### **ADDENDUM #1**

### **HVAC UNIT REPLACEMENT**

# Scenic Regional Library, St. Clair & Warrenton Branches

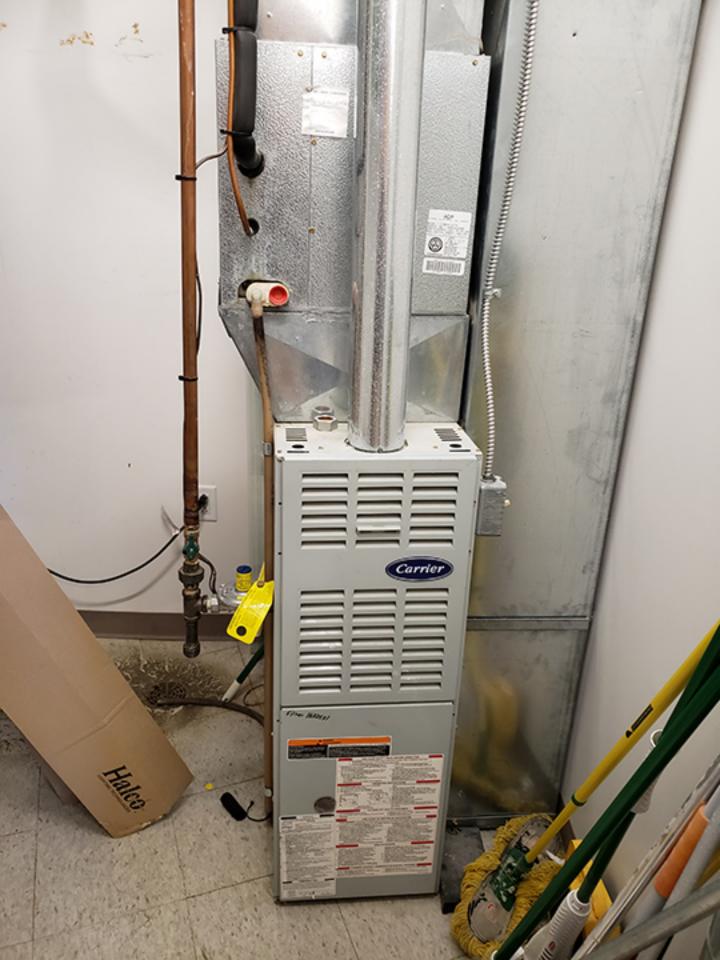
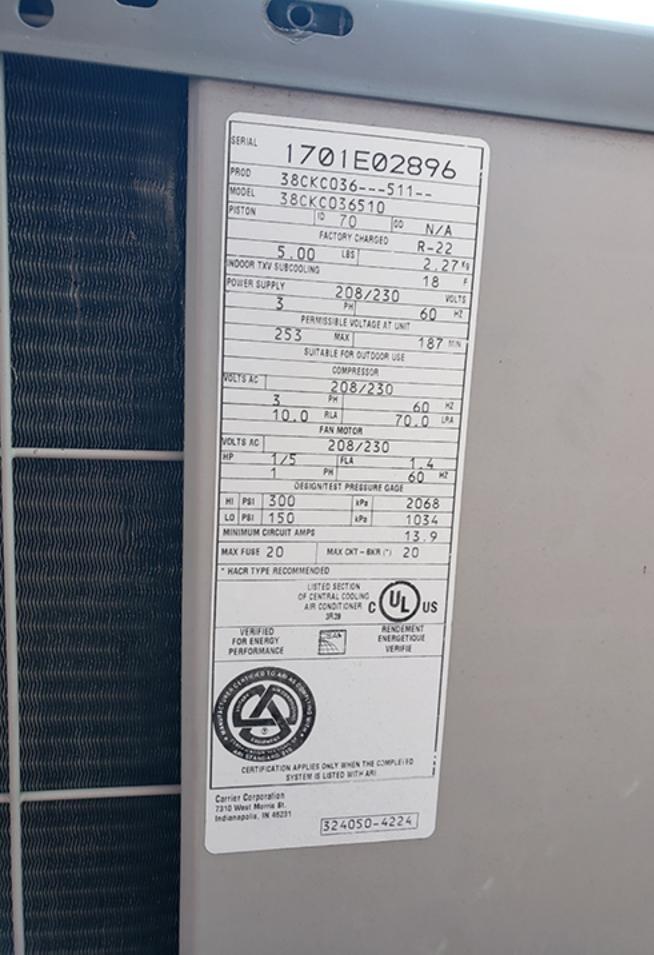
Provide new add alternate bid for the following: **Replacement of existing split system mechanical air handlers & condensers (2 Each), and thermostats (if required) at the Warrenton Branch.** Min IECC SEER rating of 17 or higher. Provide all service and utility connections. Provide all required transitions and fittings for a complete installation.

Condensers are located on the Northwest side of the building West of the entrance. One air handler is in the Janitor's Closet near the front desk. The second air handler is in the Storage Room behind the front desk.

See attached images and revised Bid Form.
